Title: State Street Campus Garage Mixed-Use project

State Street Campus Garage Mixed-Use project  
415 N. Lake Street, Madison, WI 53715  
Land Use – UDC change in zoning from UMX to PD (GDP-SIP).  
EUA Project Number: 720448-01

## **Revised Content Addressing Comments Made by the Urban Design Commission**

3 EAST ELEVATION  
1/16" = 1'-0"

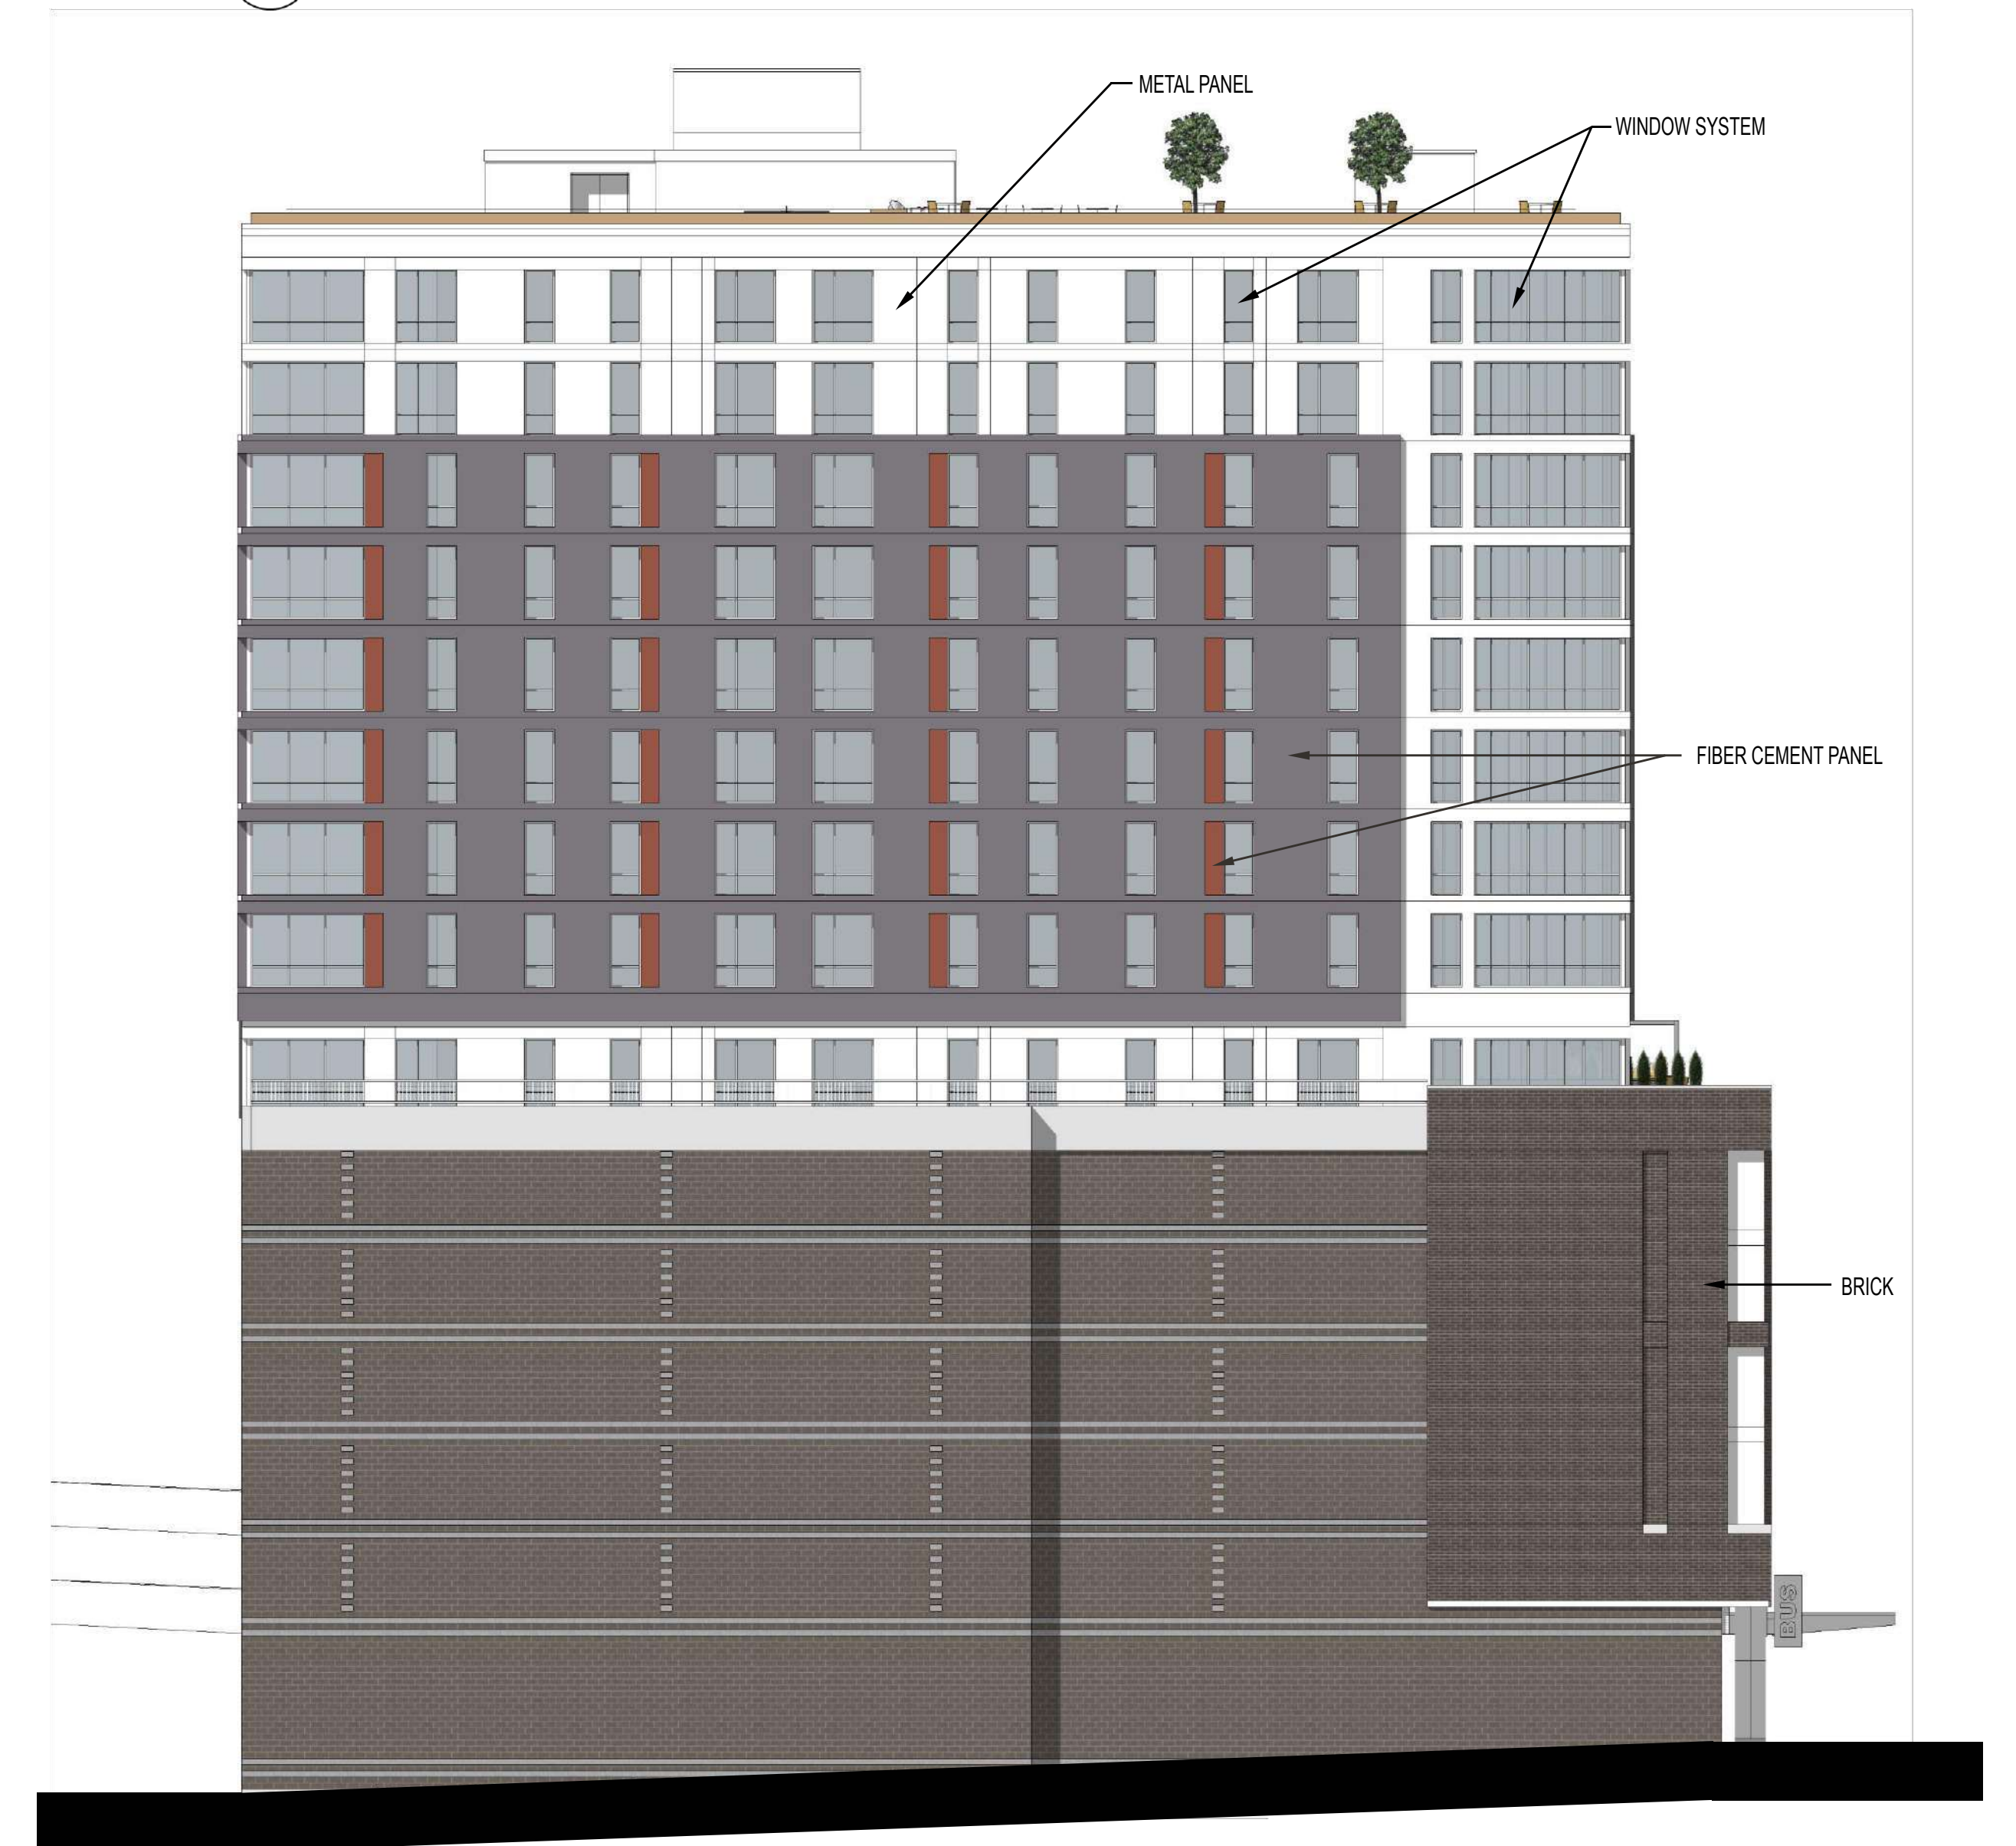
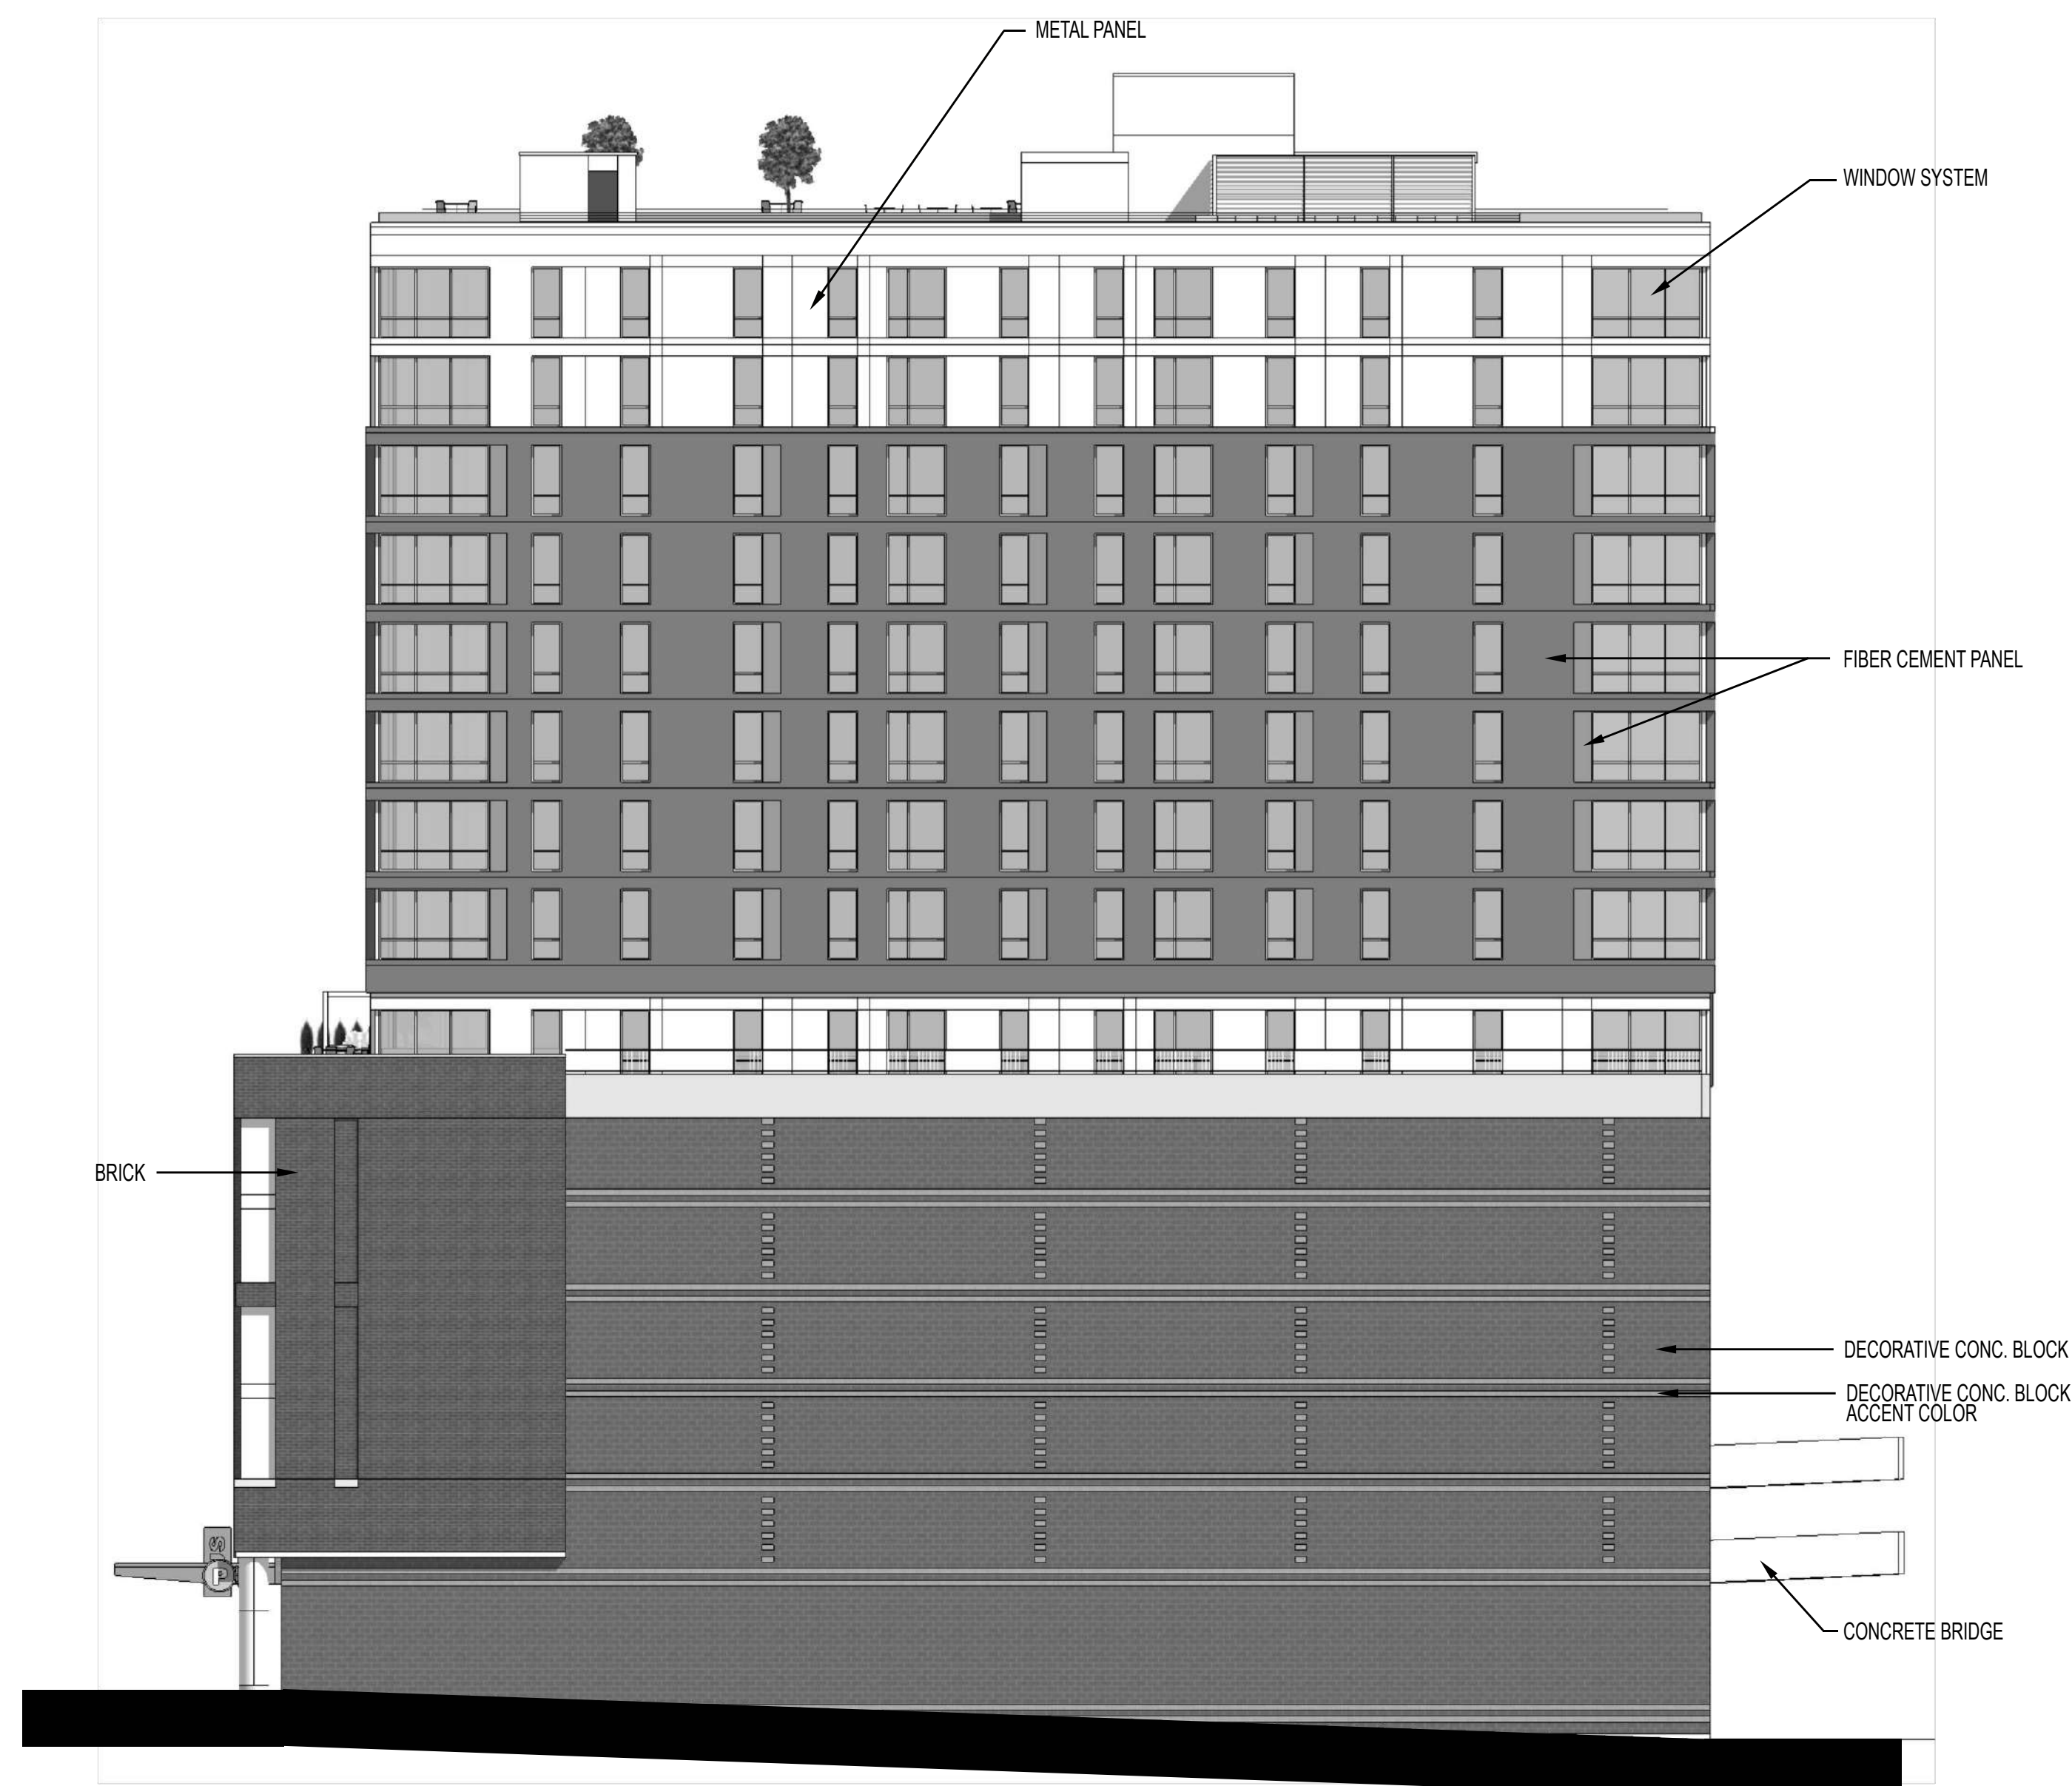
(Provide refinement of the level of design/articulation at the building corners and North/South elevations along Hawthorne Court and the exposed garage walls).

- Added design and material articulation to the north and south elevations.  
**(See Sheet A200)**
- The Hawthorne Court elevation will utilize the same burnished block that is being used on the other elevations. The two-colored block design feature on the north and south elevations will be utilized on the block areas of this elevation.  
**(See Sheet A200)**
